DART SERVICE INSTRUCTION

**TO AMEND INSTALLATION INSTRUCTIONS IIN-D412-694 REV B
AND INSTRUCTIONS FOR CONTINUED AIRWORTHINESS ICA-D412-694 REV 1**

A	NEW ISSUE		DB	14.12.11
REV.	DESCRIPTION		BY	DATE
DESIGN	DB	DART AEROSPACE LTD		
DRAWN	DB	HAWKESBURY, ONTARIO, CANADA		
CHECKED	<i>13</i>	DRAWING NO.	REV. A	
MFG. APPR.	N/A	DSI 9715	SHEET 1 OF 2	
APPROVED	<i>MM</i>	TITLE	SCALE	
DE APPR.	<i>MM</i>	REPLACEMENT WINDOW KIT		
DATE	14.12.11	NTS

D3237-1 SEAL

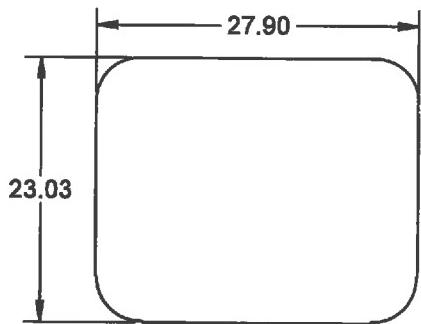
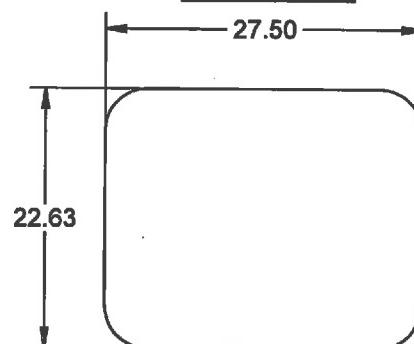
On D412-694-011 Spacedoor Installations at CHG 005 and later, the D412-694-015 Replacement Window Kit has been replaced with D412-694-115 Replacement Window Kits. The D3117-1-0980 Seal Retainer, D3117-3-0980 Seal Filler and D3136-041 Window Assembly have been replaced by a D3237-1-0980 Seal Retainer, D3237-3-0980 Seal Filler and D3136-045 Window Assembly. Operators with D412-694-011 Spacedoors at CHG 004 or earlier with the D3117-1-3 Seal in working condition may still order the D3136-041 Window as a replacement. Operators needing to replace the D3117-1-3 Seal must order a complete D412-694-115 Replacement Window Kit (seal and window) and should update the Aircraft Log Book to record the change to the new window and seal.

Installation procedure for the D412-694-115 Replacement Window Kit is identical to the installation of the D412-694-015 Window Kit (Section 3.4) of IIN-D412-694. The following diagram shows the differences between the D3117-1 Seal and the D3237-1 Seal and the differences between the D3136-041 and D3136-045 windows.

NOTE: D3136-041 Windows are NOT compatible with D3237-1 Seals and D3136-045 Windows are NOT compatible with D3117-1 Seals
